Access Compliance Report

Public Rights-of-Way

(Curb Ramps)

Intersection ID: 49359	Main Street: PARK_SOUTH_DR	Cross Street: GARDEN_PATH_LN	Location:	S
ADA ID: 51188CAE12F3	Ramp Type: PerpDiag	Initial Pass/Fail: Pass	Overall Compliance: No	Severity Score: 15
Codes/Mitigation Info/Possible Solution		Field Measurements/Component Compliance

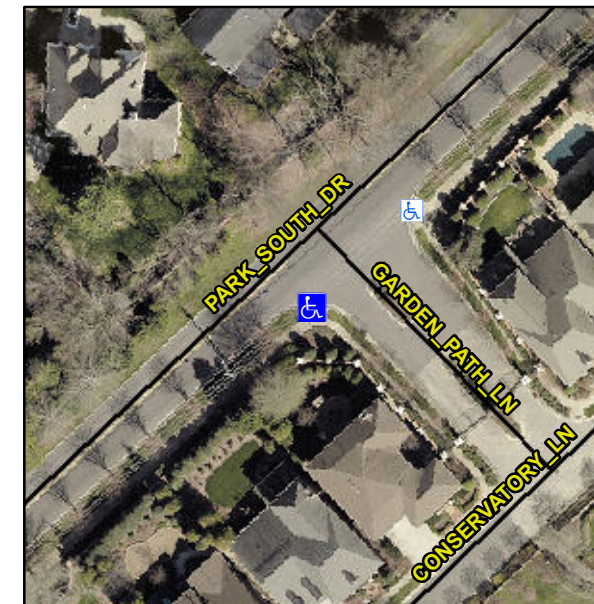
Not Found, R304.2.1, R304.2.2-Perp, R304.3.2-Para, R304.5.3, R304.5.4

Compliance	Description	Data	Compliance	Description	Data
N/A	Ramp Length (in)	118.0	Yes	Ramp Slope (%)	5.7
Yes	Ramp Width (in)	48.0	Yes	Ramp XSlope (%)	1.1
N/A	Flare Type LT	Sloped	N/A	Flare Type RT	N/A
N/A	Flare Slope LT (%)	6.1	Yes	Flare Slope RT (%)	5.0
N/A	Flare Traversable LT?	Yes	N/A	Flare Traversable RT?	Yes
No	Landing Length (in)	N/A	Yes	DWS Provided?	Yes
No	Landing Width (in)	N/A	Yes	DWS Contrast?	Yes
No	Landing Slope (%)	N/A	Yes	DWS Length (in)	24.0
No	Landing X Slope (%)	N/A	Yes	DWS Full Width?	Yes
N/A	Landing Curb? (Y/N)	No	Yes	DWS Offset (in)	1.0
N/A	Shared Landing?	N/A			
Yes	Gutter Ponding?	No	No	Gutter Slope (%)	5.8
Yes	Gutter Lip Ht (in)	0.0	Yes	Gutter X Slope (%)	0.2
N/A	Painted X Walk1?	No	N/A	Painted X Walk2?	No
	X Walk 1 Direction	To NE		X Walk 2 Direction	To N
N/A	X Walk 1 Width (in)	N/A	N/A	X Walk 2 Width (in)	N/A
	X Walk 1 Slope (%)	3.1		X Walk 2 Slope (%)	4.9
	X Walk 1 X Slope (%)	2.4		X Walk 2 X Slope (%)	2.5

N/A	Ramp inside XWalk1?	N/A	N/A	Ramp inside XWalk2?	N/A
	Road Slope (%)	0.6	N/A	Clear Space?	Yes
	Road X Slope (%)	5.1	N/A	Clear Space to XWalk (in)	N/A
Yes	Any Obstructions?	No	Yes	Storm Grate/Utility Hazard?	No
	Obstruction Type			Storm Grate/Utility Type	
		N/A			N/A
			Yes	Surface Condition? (G/P)	Good

Remove & Replace Curb Ramp With Two New Directional Ramps or Equivalent. Remove & Replace Gutter.
